Hidden Shares

New Home Construction Application

Details & Notes
 21 Hidden Shores Drive
 Cisco, Texas 76437

BAKTER - 1600 3 BED ROUGH DRAFT #1			
Date: SEPT 2014	Scale: 1/4" = 1'	Sq. Ft.	gpf
FLOOR PLAN AND ELEVATIONS			
Page #: 1 OF 1	Drawing #:

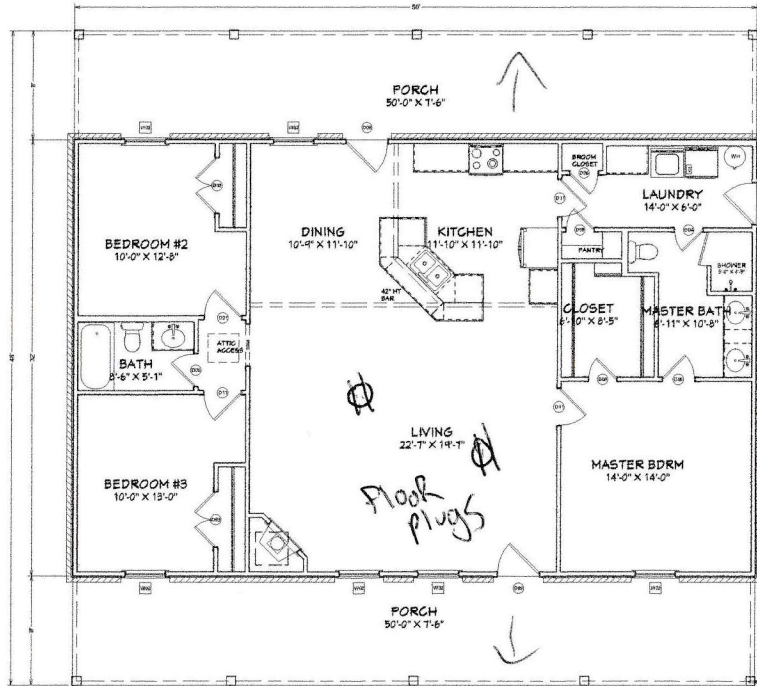
Rock on front only
